Ebey's Landing National Historical Reserve

Certificate of Appropriateness

WhidbeyHealth

COA-26-029

**ELECTRICAL SITE PLAN
ENLARGED**

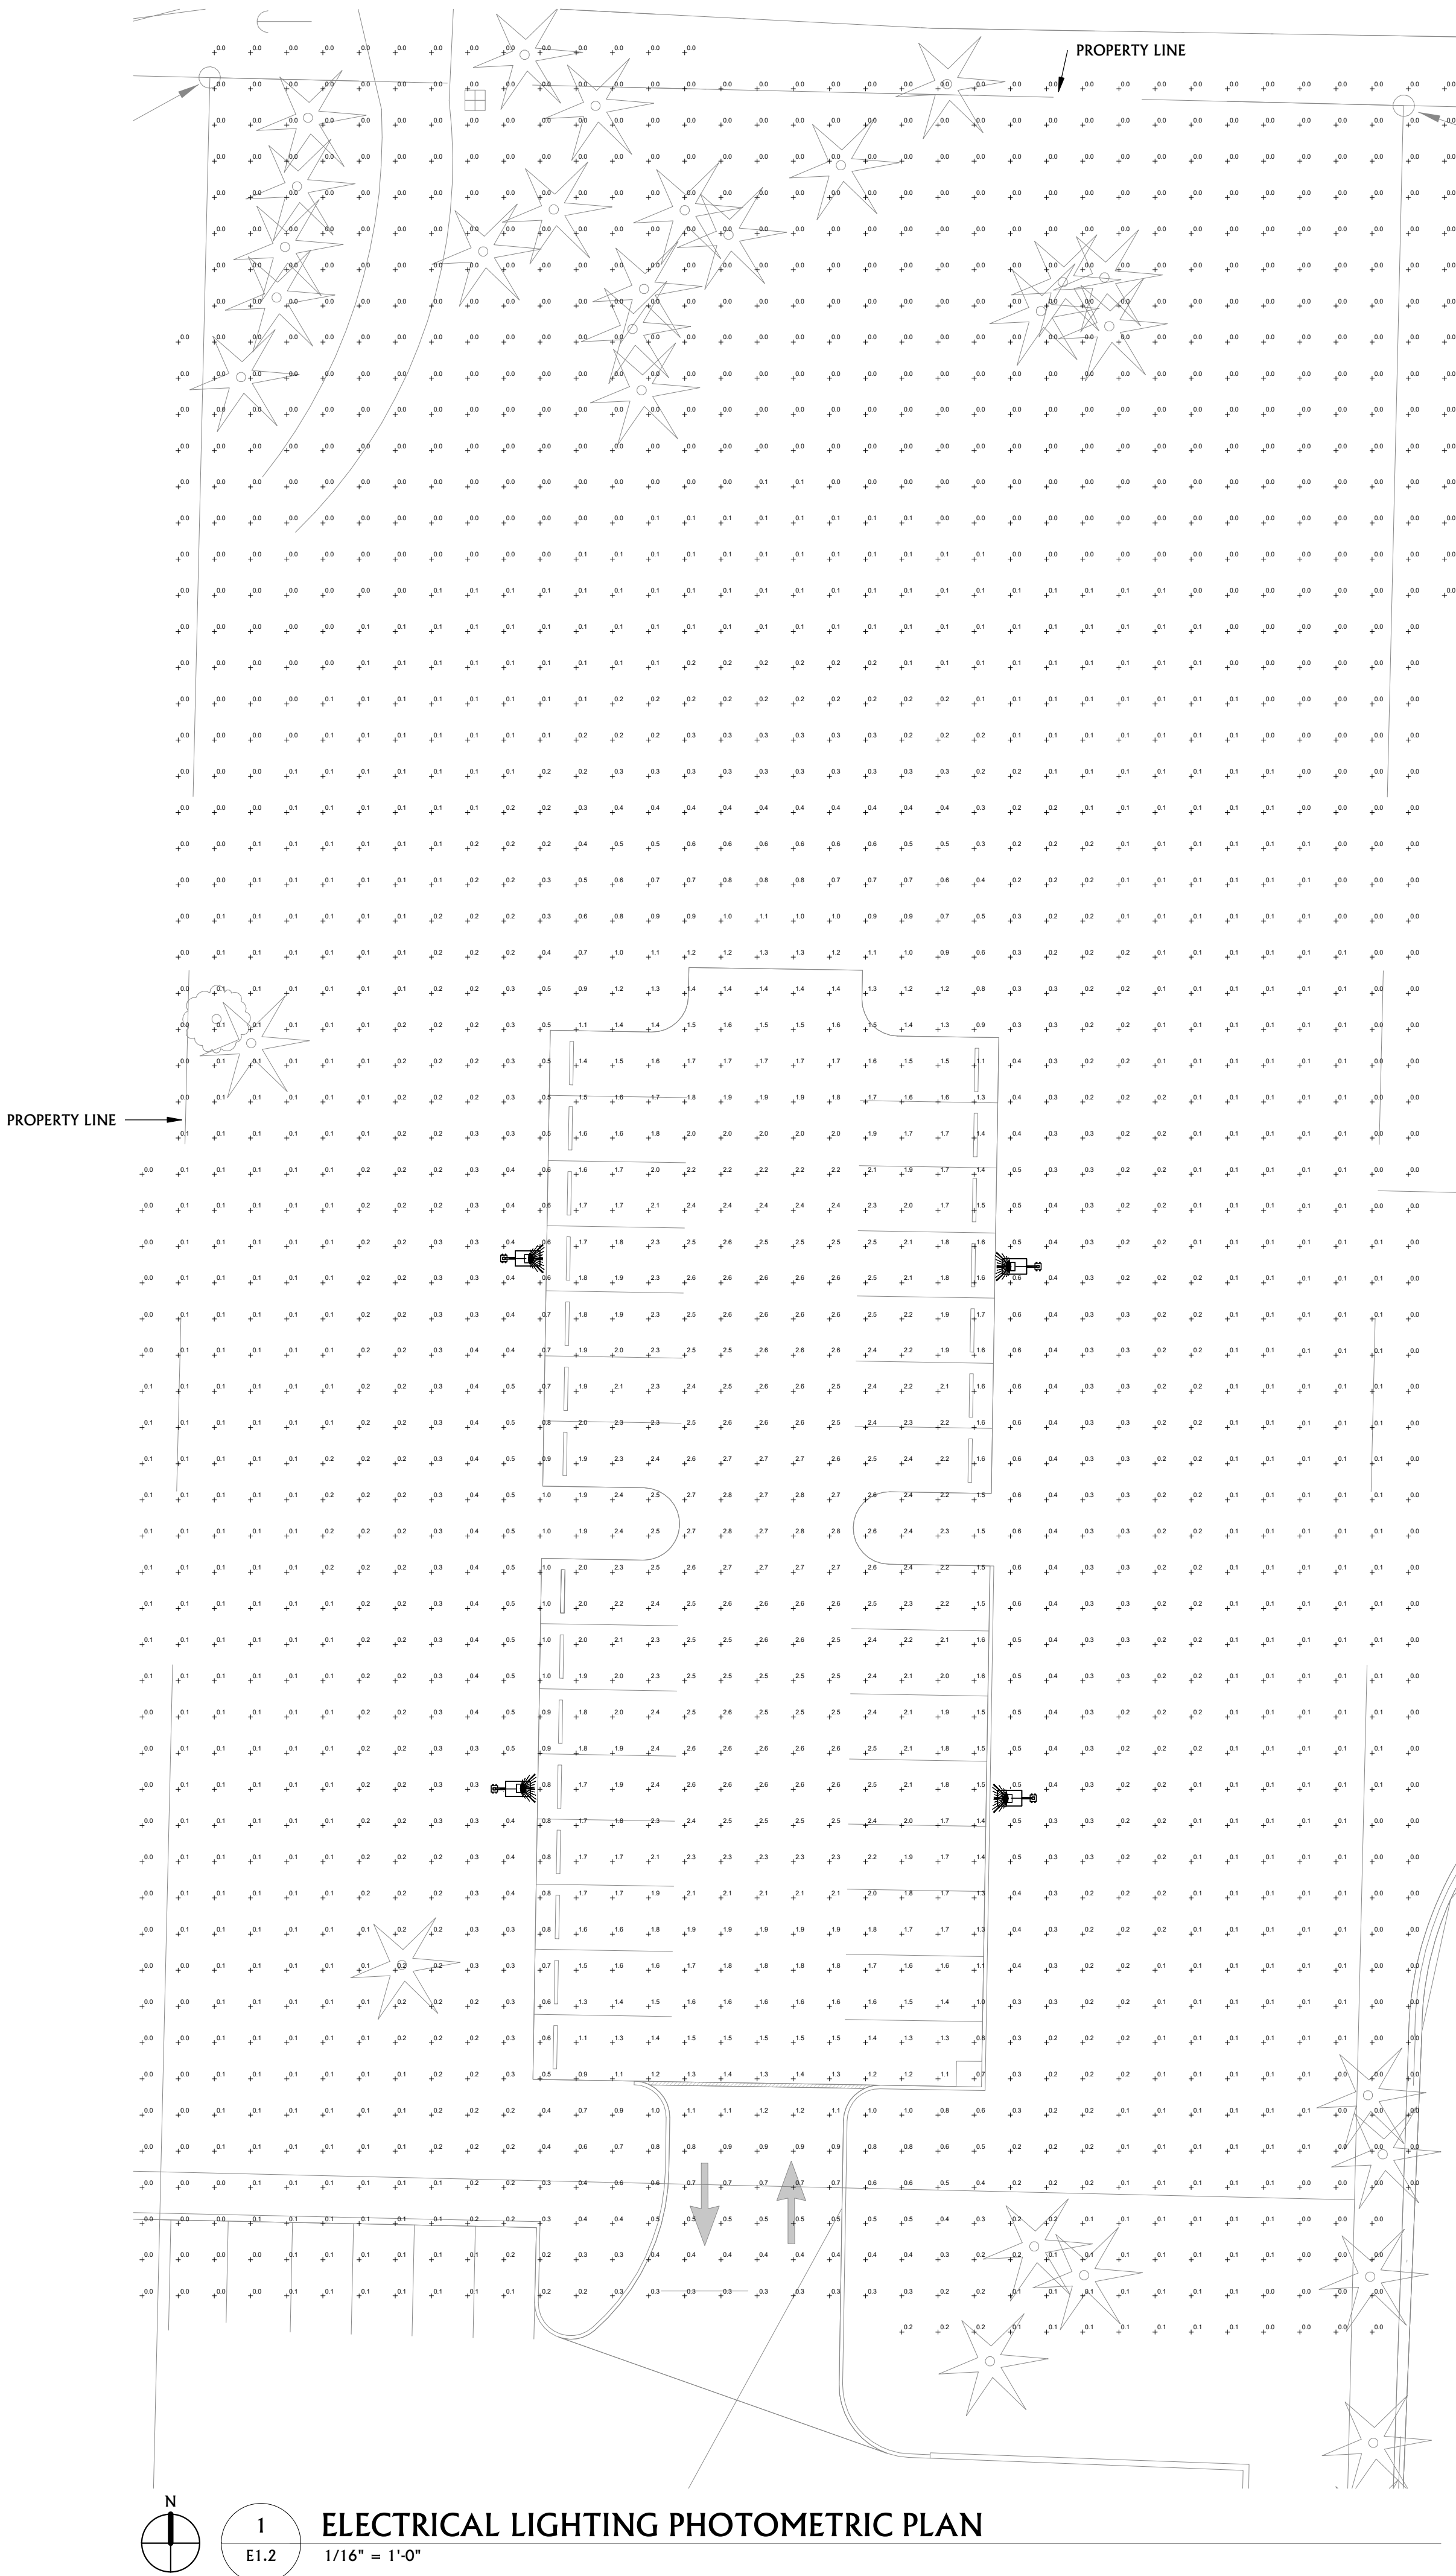
Staff analysis: The applicant proposes four pole-mounted light fixtures to provide illumination for the parking facility. The fixtures will incorporate glare shields and will be designed to direct light onto the parking area while minimizing horizontal glare and light trespass onto adjacent properties. The proposed lighting levels are below the maximum allowances of the International Energy Conservation Code.

The photometric plan (Attachment A, Sheet E1.2) indicates that illumination will be contained within the project site and will not result in light trespass onto the adjacent property to the west. The fixtures will also be equipped with occupancy sensors that will reduce light levels when the parking area is not actively being used, further minimizing unnecessary illumination during nighttime hours.

Additional measures are proposed to reduce potential impacts to the adjacent property. Cedar trees will be planted along the western property line to provide visual screening, and the parking facility will be approximately six (6) feet lower than the adjacent property to the west. Together, these measures will help screen the light fixtures and reduce the potential for glare and light trespass.

The proposed lighting consists of multiple pole-mounted fixtures rather than a single remote light source, allowing illumination to be distributed throughout the parking area at lower intensities. Based on the proposed fixture design, lighting controls, photometric analysis, landscaping, and recessed site design, staff finds that the proposal is consistent with the Reserve's lighting guidelines and will provide necessary illumination while minimizing impacts to surrounding properties and the character of the Reserve..
